SOUTH CAROLINA
 DEPARTMENT OF HIGHWAYS AND PUBLIC TRANSPORTATION
 P.O. BOX 191
 COLUMBIA, S.C. 29202

MEMORANDUM TO DESIGN GROUP LEADERS

Subject: Diaphragms for Prestressed Beam Spans

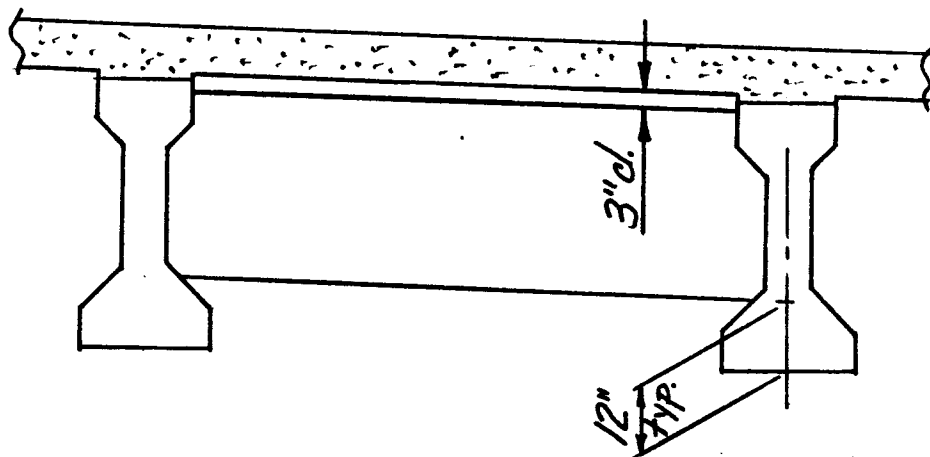
Diaphragms for prestressed beam spans should be detailed without the 5" fillets on the bottom face. The bottom of the diaphragm should be detailed 12" above the bottom of the beam. See the sketch below.
